Eco Couture Ltd.

Mogorkhal, Dhaka Bypass Road, Joydebpur, Gazipur
(23.972172 N, 90.390718 E)

25th November 2015

Observations

Nonconformities and deformations observed at several steel connections

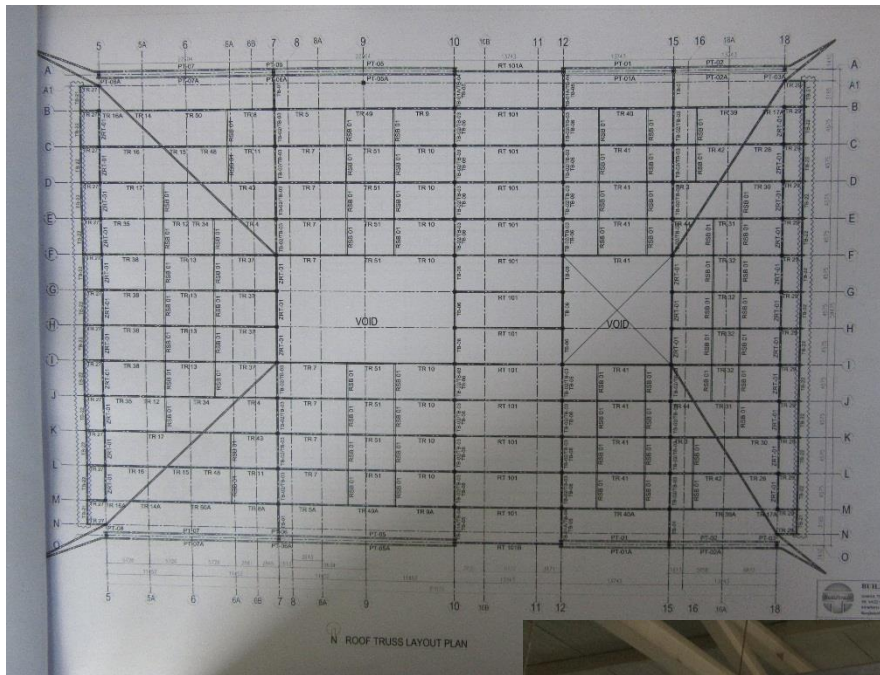
Nonconformities and deformations observed at several steel connections
 Diagonal truss elements welded directly on web of I-section without proper detailing (no stiffeners)
 This caused buckling & crippling at the web of profile.

Item No.	Observation	Recommended Action Plan	Recommended Timeline
1	Building 1- Factory Building Nonconformities and deformations observed at several steel connections	Building engineer to locate and inspect the deformations at vertical transfer elements between trusses (indicated at observation slides)	6-weeks
2	Building 1- Factory Building Nonconformities and deformations observed at several steel connections	Building engineer to ensure structural steel connections (especially to the web of sections) has been designed and fabricated as per code for vertical & wind loads.	6-weeks
3	Building 1- Factory Building Nonconformities and deformations observed at several steel connections	Building engineer to verify main frame connections has proper capacity by carrying out calculations	6-weeks
4	Building 1- Factory Building Nonconformities and deformations observed at several steel connections	Monitor any further deformation at connections	6-months

5	Building 1- Factory Building Nonconformities and deformations observed at several steel connections	Carry out remedial works where required.	6-months

Lack of diagonal stability elements at roof level

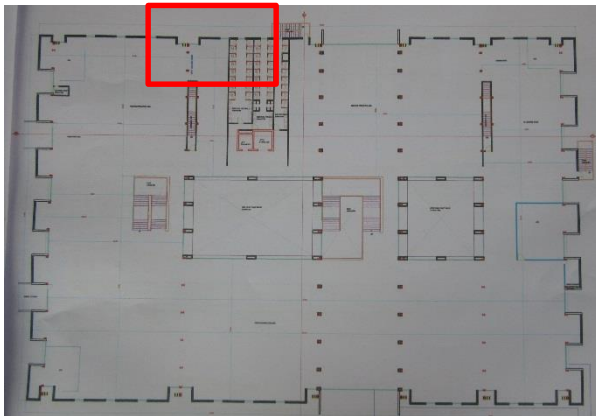
Stability at roof level is provided by orthogonal frame elements at bottom flange of truss and purlins at top.

No diagonal bracing has been provided.

Building engineer to verify roof stability without diagonal bracing is adequate to resist wind loads.

Item No.	Observation	Recommended Action Plan	Recommended Timeline
6	Building 1- Factory Building Lack of diagonal stability elements at roof level	Building engineer to carry out checks that stability of truss system at roof level is adequate and provide stability elements where required.	6-months
7	Building 1- Factory Building Cracking at brick walls on cantilever portion of 1st floor	Verify the capacity of cantilever and check if excessive deflection exists. Remove excess loading where needed.	6-months
